SERVICE BULLETIN

APPLICABILITY: 2020-24MY Legacy & Outback

SUBJECT: Genuine Battery Replacement

NUMBER: 07-213-22R

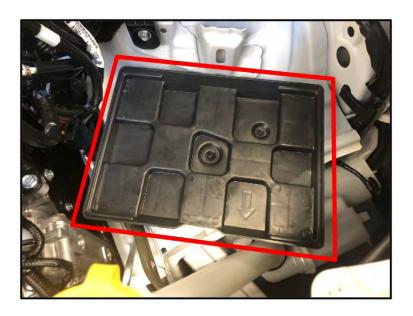
STEP 5: Assemble the new battery holder (p.n. 82184SG000), NEW rear holding rod (p.n. 82161SJ000), and the ORIGINAL front holding rod as shown below. The original rod nut can be transferred to the new rear holding rod.
